**COMMISSION OF ARCHITECTURAL REVIEW  
STAFF REPORT  
February 27, 2018, Meeting**

5. **COA-029597-2018** (J. & S. Bliley) **2609 Monument Avenue  
Monument Avenue Old and Historic District**

**Project Description:** **Construct a second story addition.**

1950 Sanborn Map

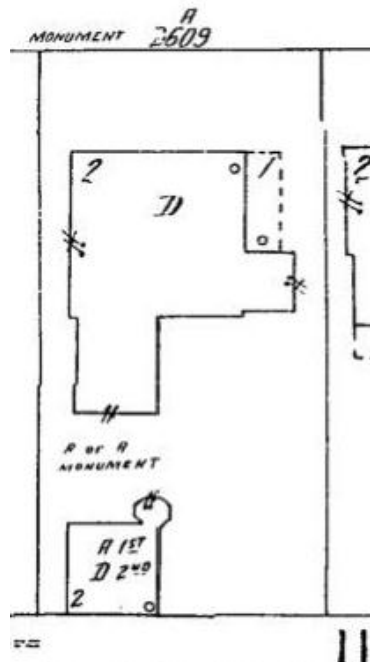
Based on the 1950 Sanborn map, it appears that the structure has not been altered from its original plan. The only documented alteration staff was able to confirm was the enclosure of the side porch with glass in 1991. The application for the alteration states that "no change to the structure occurred and no alteration to the home occurred."
